# City of Rialto

**Title:** Traffic Impact Analysis - Foothill Apartment TIA - 534 Foothill Boulevard  
(ACTION ITEM)

For Transportation Commission Meeting [November 3, 2021]

### **Traffic Impact Analysis - Foothill Apartment TIA - 534 Foothill Boulevard (ACTION ITEM)**

**Exhibit 4.12 - Street Section**

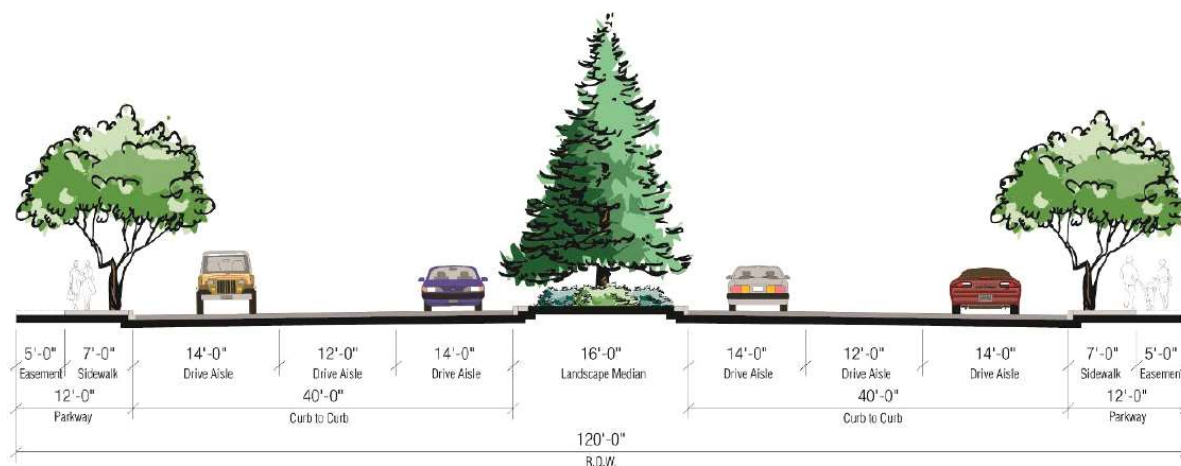
In addition to access configuration, it is recommended that the Project construct Foothill Boulevard at its ultimate half-width as a Modified Major Arterial I (120-foot right-of-way) from the western Project boundary to the eastern Project boundary consistent with the City's standards. This will meet the requirements of the Foothill Boulevard Specific Plan as shown below:

- Provide recommendations related to approval.
- Recommend improvement of Foothill Boulevard along the project frontage to full half-width of 120' consistent with a Modified Major Arterial I (120-foot right-of-way) consistent with City Standards including median improvements or access restrictions/improvements subject to the satisfaction of the City Engineer with final configuration to be determined during final design.
- Recommend payment of applicable DIF fees.
- Recommend no payment of Fair Share fees.
- Recommend approval to the Planning Commission.
